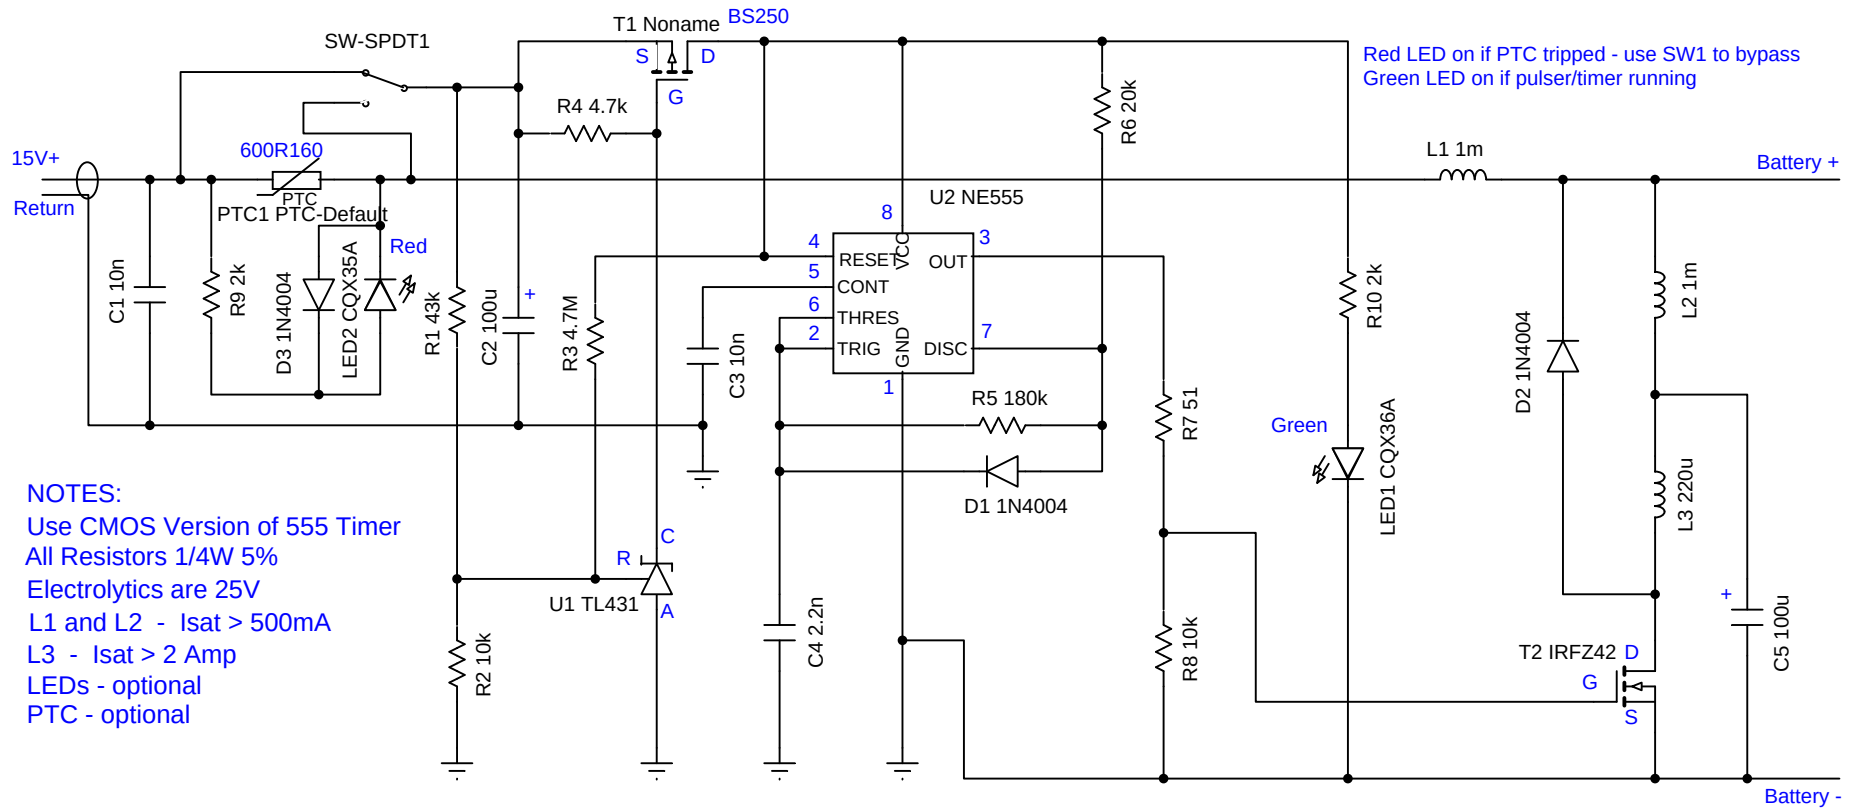
C2 is actually supposed to be 2.2nF not 22nF
